CITY OF BOULDER
PLANNING BOARD AGENDA ITEM
MEETING DATE: April 7, 2016

AGENDA TITLE: Concept Plan (case no. LUR2015-00106) proposal for expansion of the Frasier Meadows congregate care facility at 350 Ponca Pl. and 4950 Thunderbird Dr. within the RH-5 zone district. The proposal includes renovations to existing buildings; expansion of existing assisted living and skilled nursing facilities, wellness center and arts and education facilities; and a new 5-story, 55' building containing 98 independent living units.

DATE OF COMMENTS: **January 29, 2016**
 CASE MANAGER: **Chandler Van Schaack**
 PROJECT NAME: **Frasier Meadows Expansion**
 LOCATION: **350 PONCA PL**
 COORDINATES: **S01W02**
 REVIEW TYPE: **Concept Plan Review & Comment**
 REVIEW NUMBER: **LUR2015-00108**
 APPLICANT: **Vince Porreca for Frasier Meadows**
 DESCRIPTION: **Concept Plan Review for the addition of 98 unit Independent Living Units, addition of Education and Arts facility, and expansion of Wellness Center.**

Figure 6: Proposed Site Plan

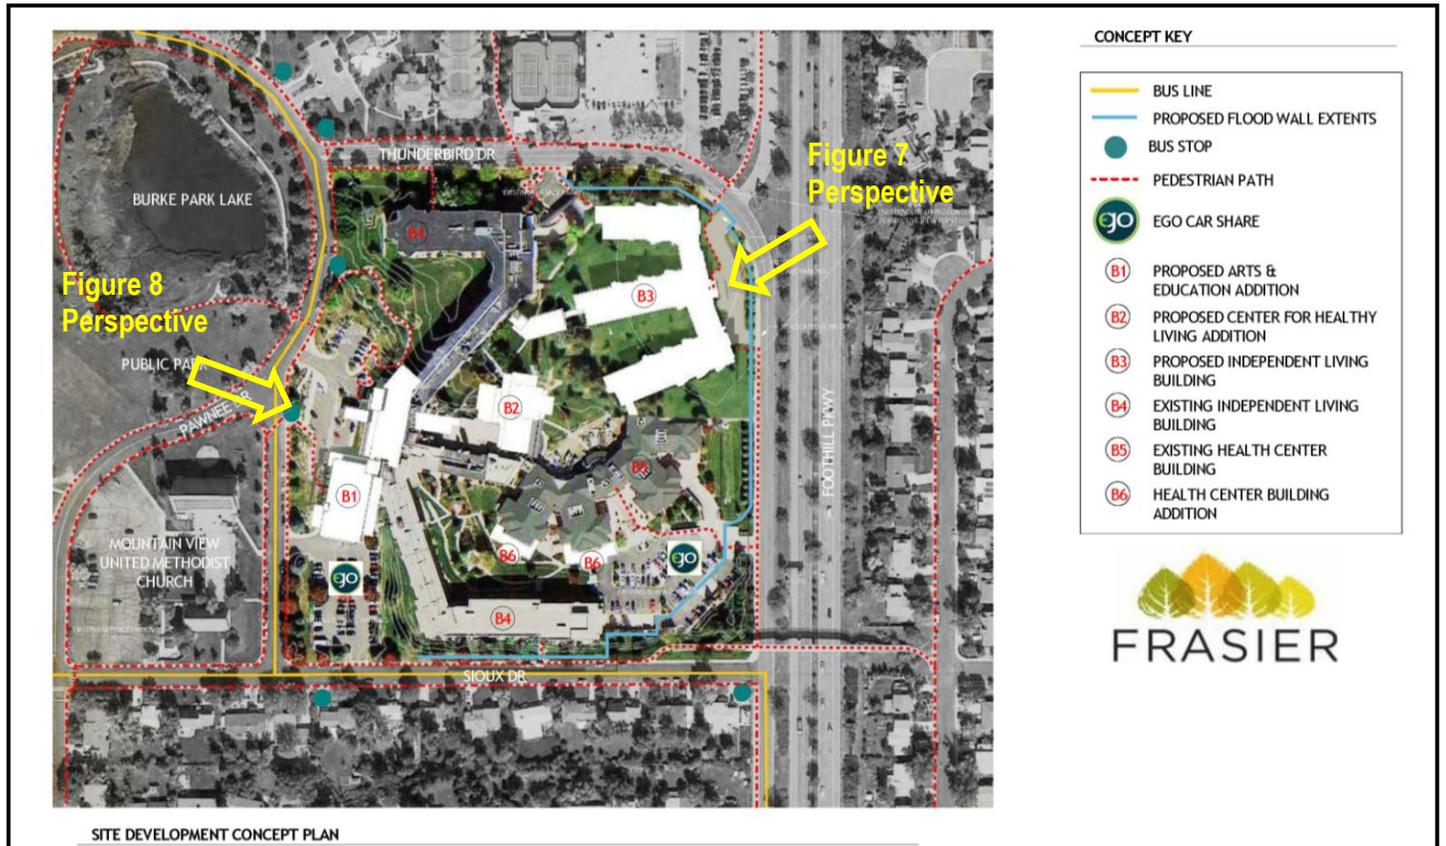
As noted in the development review comments included as [Attachment B](#), staff does not support the proposal to add an additional curb-cut to the site when there are already multiple existing curb-cuts. Staff understands that given the size of the site multiple curb cuts may be beneficial; however, there appear to be opportunities to eliminate curb-cuts along Thunderbird Drive which will provide safety benefits to the multi-use path along Thunderbird Drive. The applicant should continue to work with staff prior to Site Review to explore potential improvements to the site access and circulation. City Parks staff has also indicated a desire to work with the applicant and Transportation staff to look at the possibility of providing an improved pedestrian crossing on Pawnee Dr. north of the entrance to the parking lot serving proposed building B1.

3. Staff does not concur with the proposal to add an additional curb-cut for a site which already has multiple curb-cuts. Staff understands that given the size of the site multiple curb cuts are beneficial; however, there appears to be opportunities to eliminate curb-cuts along Thunderbird Drive which will provide safety benefits to the multi-use path.
